DOCUMENT CHANGE REQUEST

DCR number	317	Changes required for:	N/A	Originator:	Olivier Masson Chief
Date:	2007/02/01	Date sent:	2007/02/01	Organisation:	CNES
Status:	IMPLEMENTED

Title: Contacts Coaxial Crimp-type and Solder-Type for 3401/001 and 3401/002 Connectors

Number: 3401/004 Issue: 2

FIGURE 2(a) – PHYSICAL DIMENSIONS (CONTINUED)

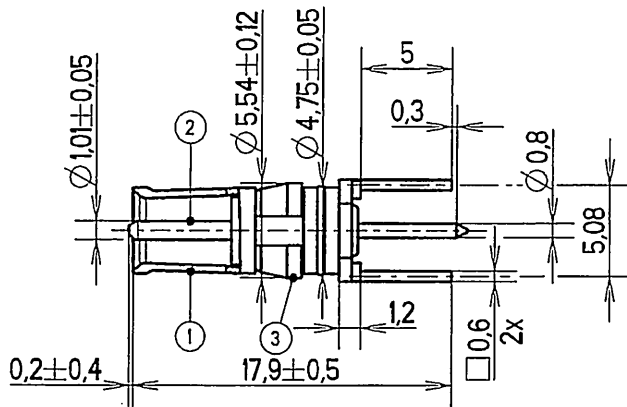
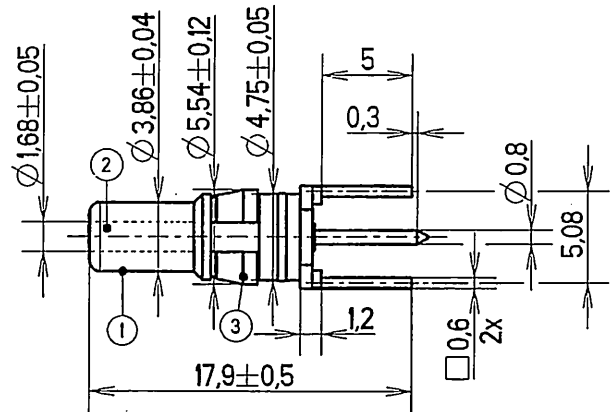
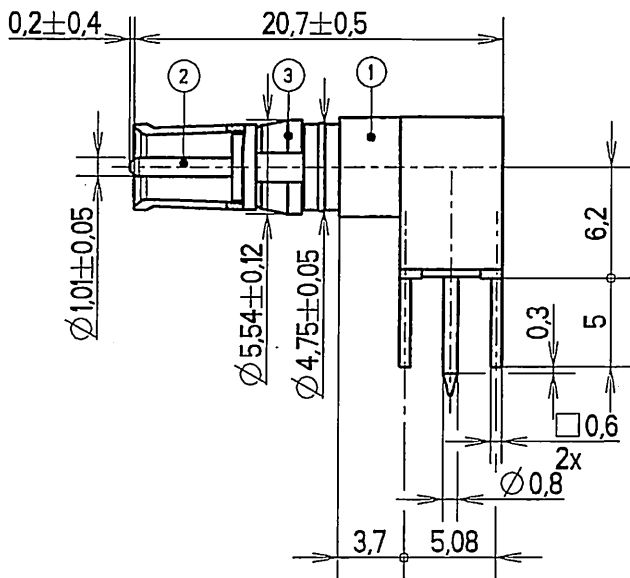
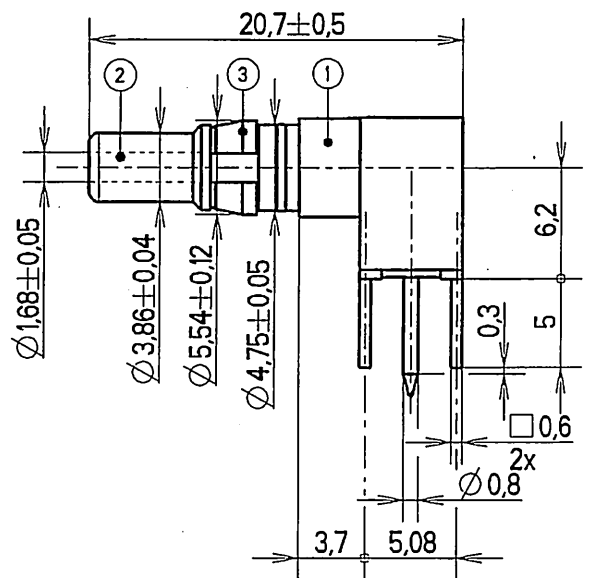
6 - Figure 2, Figures for new variants 21 to 24 added as shown in the attachment.

Items 1, 3, 6, 7, 8, 17, 18, 29 - Introduction of new variants 21 to 24 per original DCR317.

FIGURE 1 - PARAMETER DERATING INFORMATION

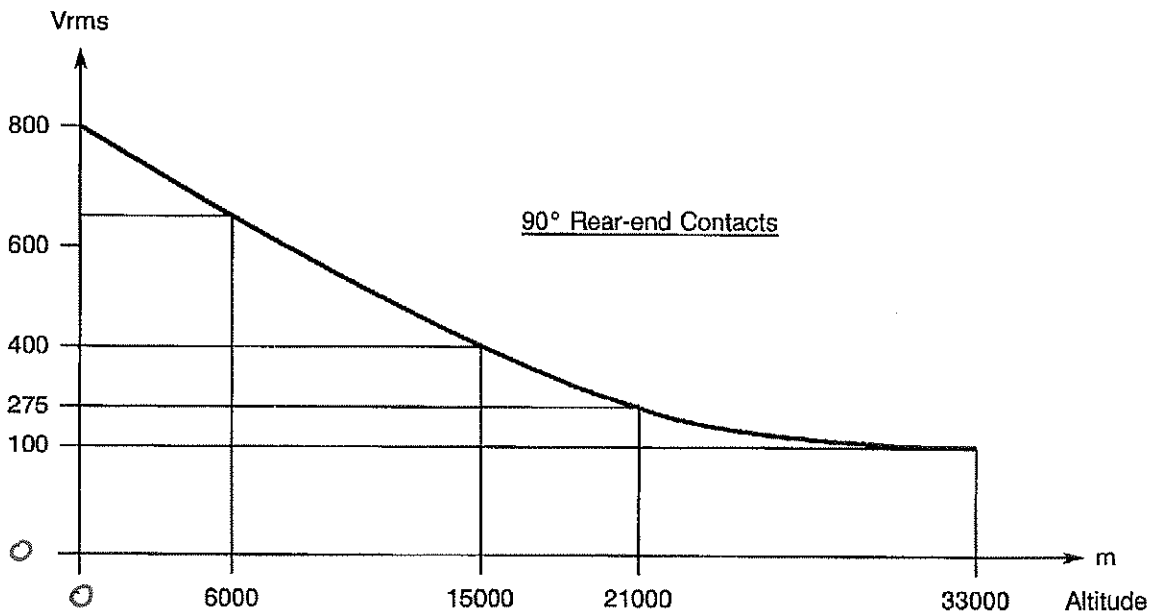
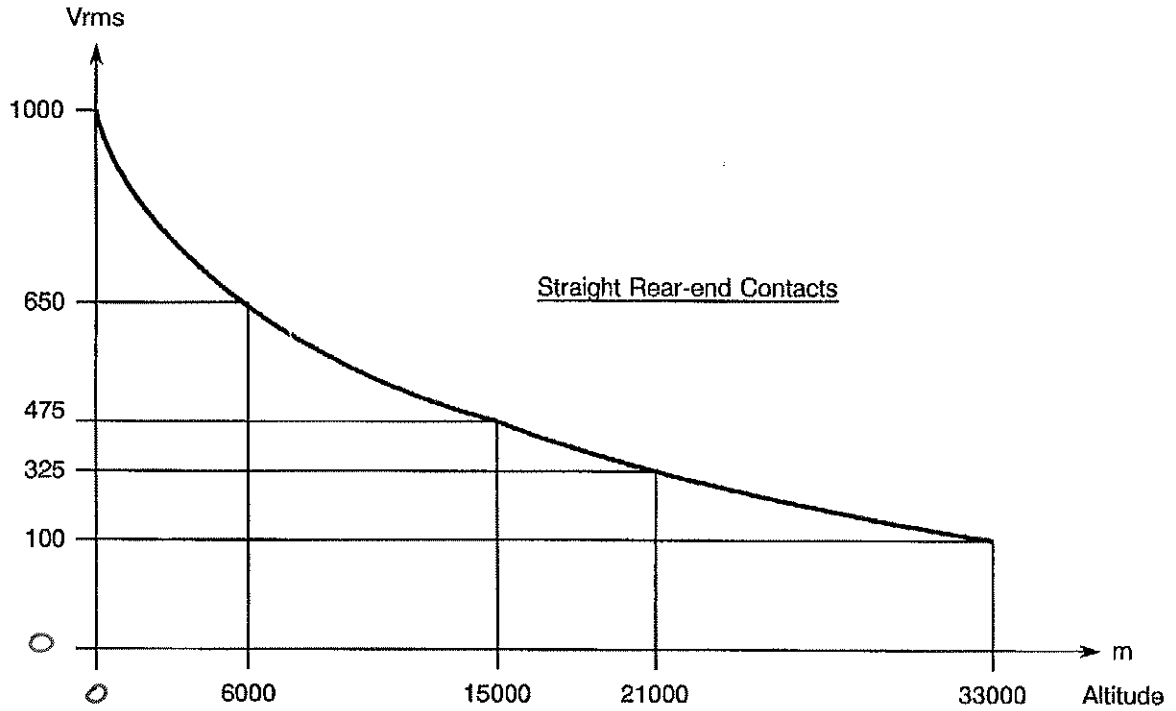
5 - Figure 1, add '0' labels to x & y axes for both figures

FIGURE 2 – PHYSICAL DIMENSIONS (CONTINUED)

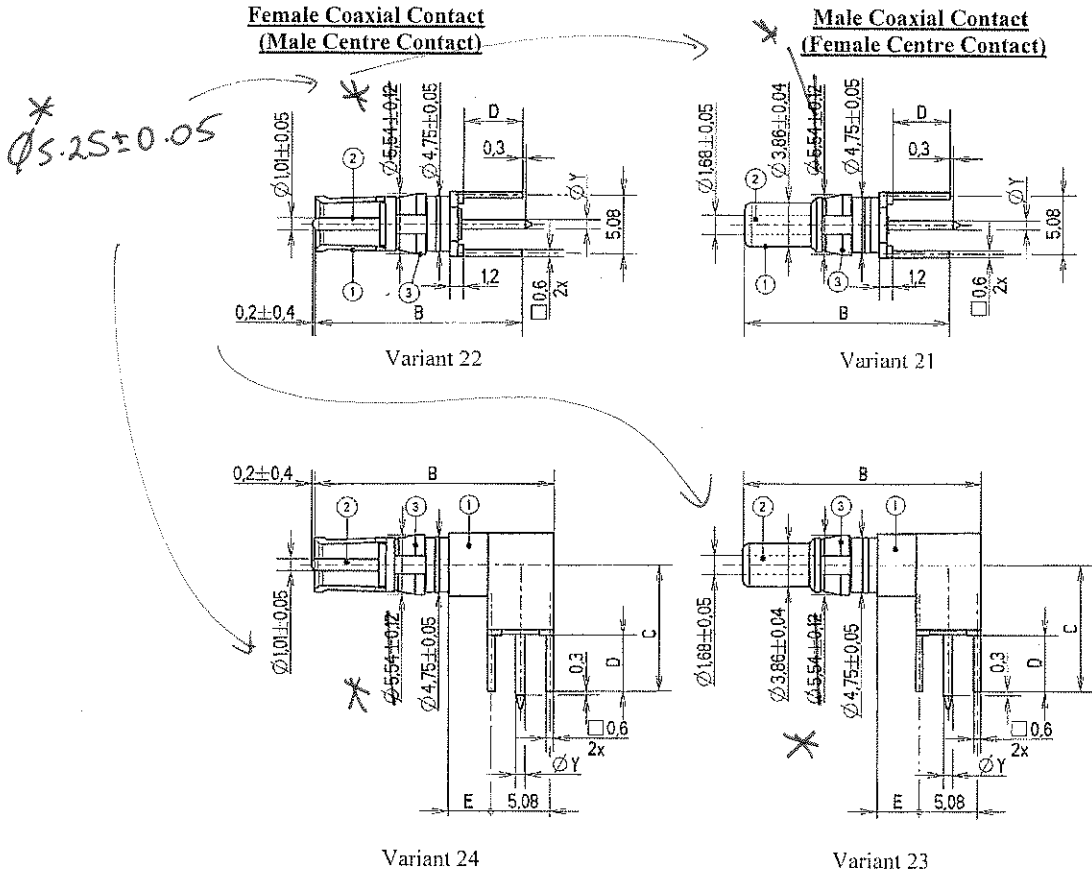
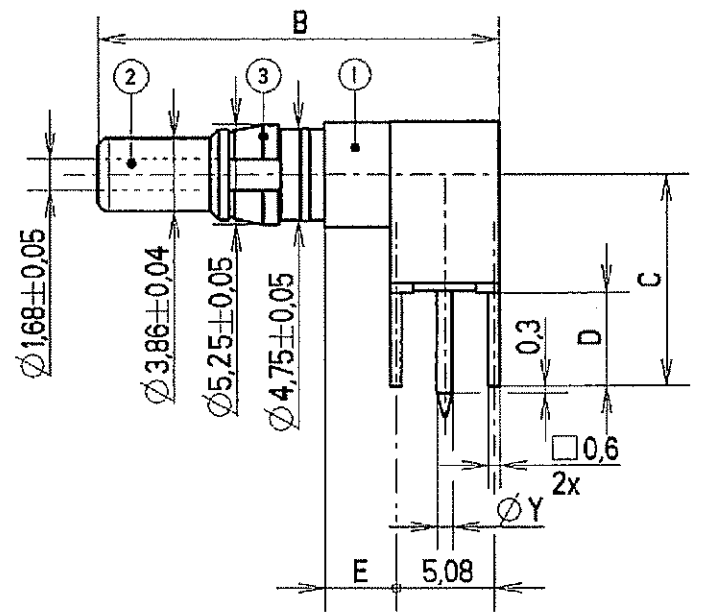
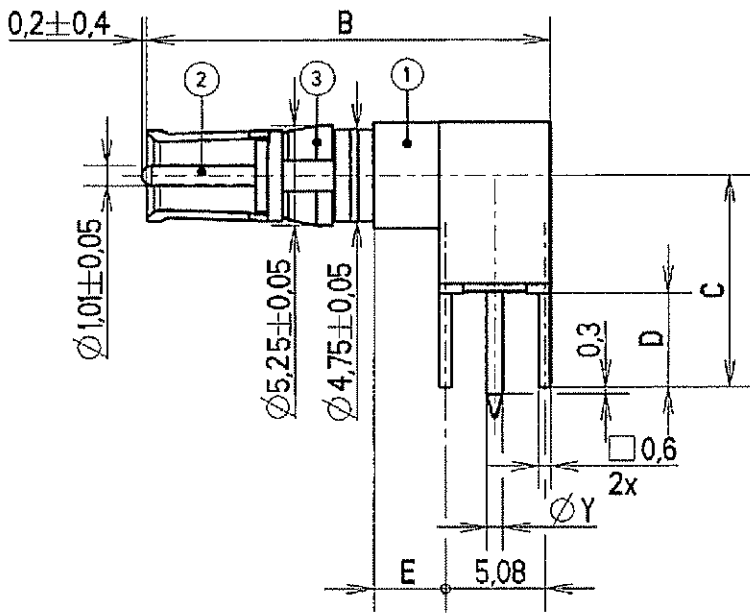
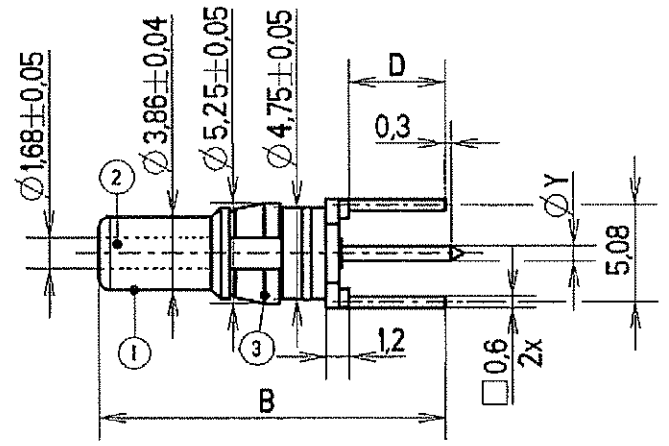
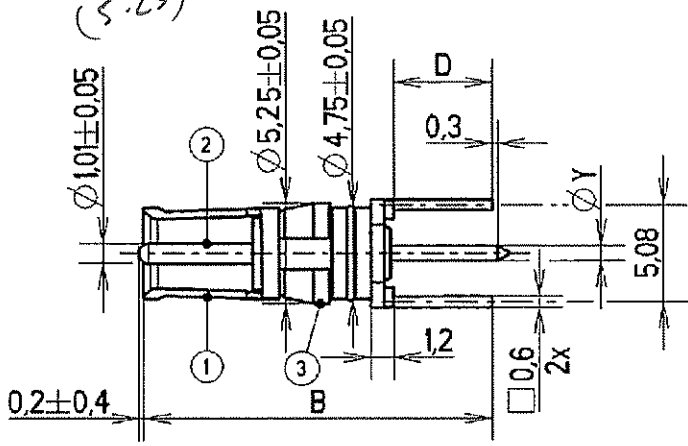
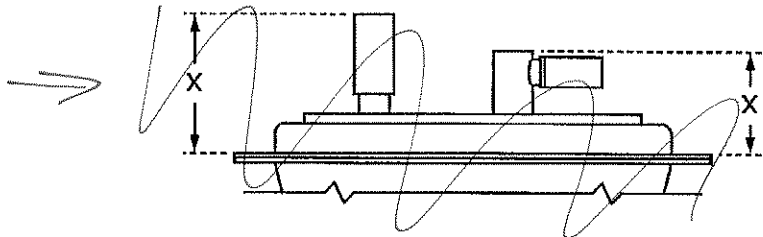
New Page

FIGURE 2 - PHYSICAL DIMENSIONS (CONTINUED)

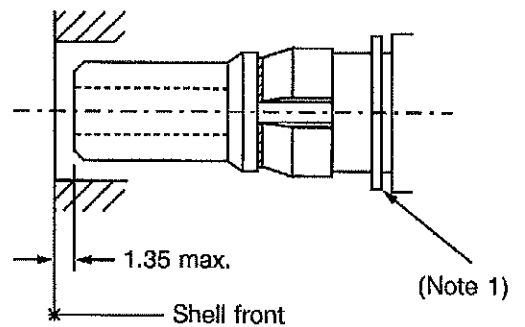
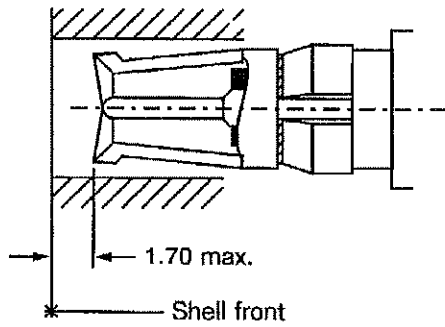
7 - Figure 2 (page 10) Maximum protrusion figure amended as shown in the attachment.

replace by
new figure
attached.

FIGURE 2 – PHYSICAL DIMENSIONS (CONTINUED)

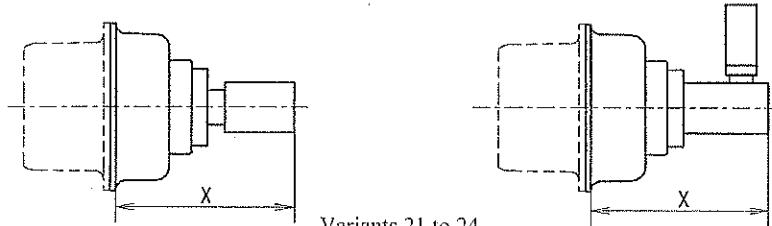
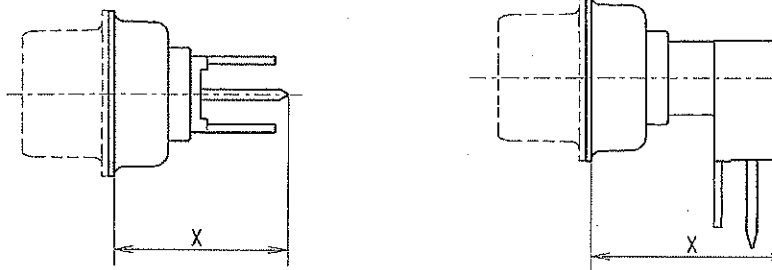
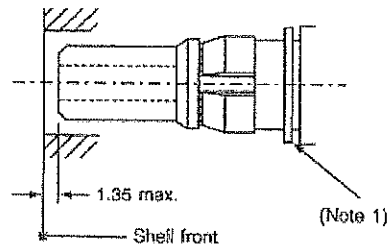
See Page ~~X~~ for value of X. → page ~~12~~ ?
